Manufacturer Declaration

Additional hints for compensating disturbances in TouchDIM operation mode of QT*i* DALI ballasts

Fig. 1

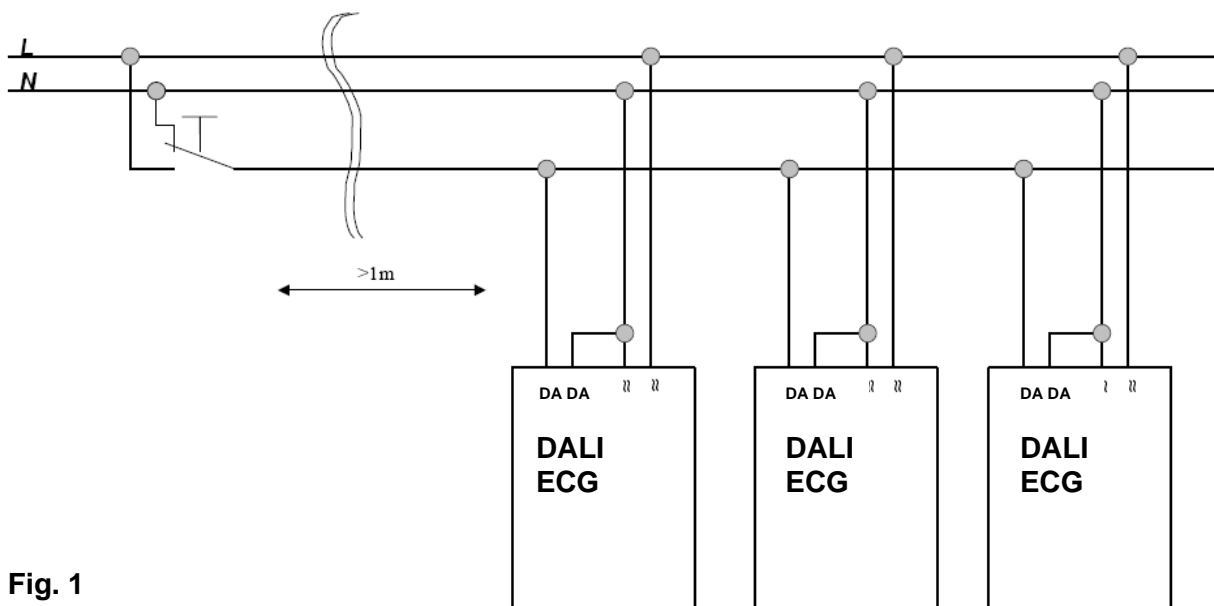
1) Toggle Switch

Using a Toggle Switch between Phase L and Neutral Line N (see Fig. 1) a connection of the two DALI lines can be realized in ECGs` Standby mode. As a result, no disturbance coupling effect is possible.

Fig. 2

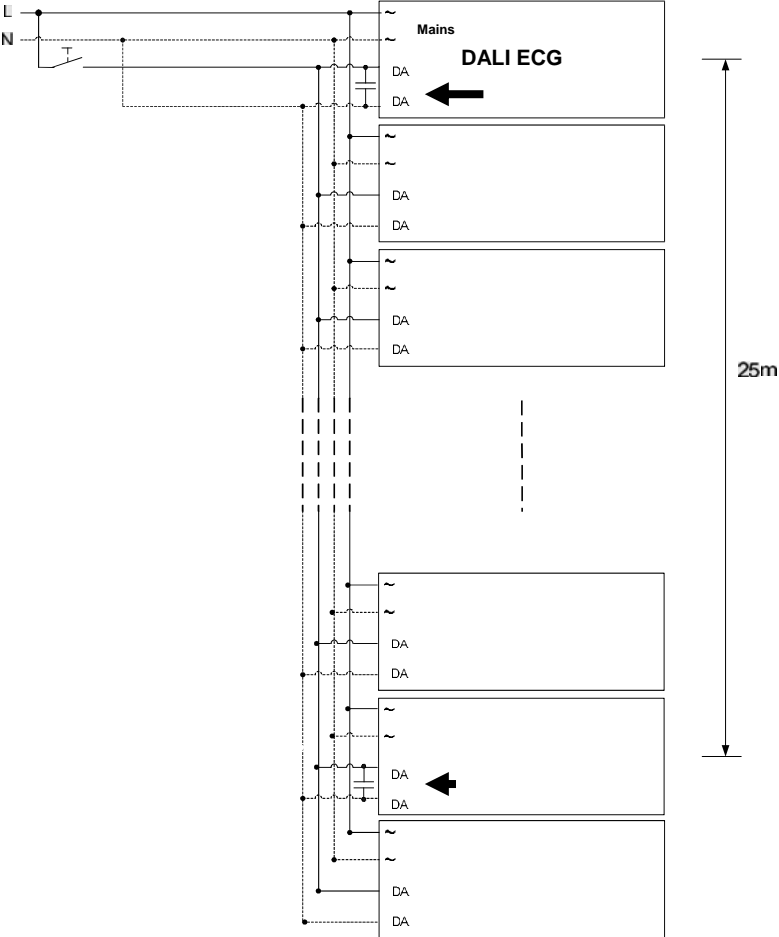
2) Capacitor for Compensation

Using DALI line lengths > 25m leads to a capacitive compensation of at least 10nF/m line length (i.e. 300nF at 30m, 400nF at 40m etc.). That capacitive compensation (250V, X2 type) has to be installed in parallel to **one ECG`s DALI** interface. Another possibility is, to achieve the compensation via

parallel switching of capacitors being installed to several ECGs (total capacity has to be achieved, see Fig. 2).
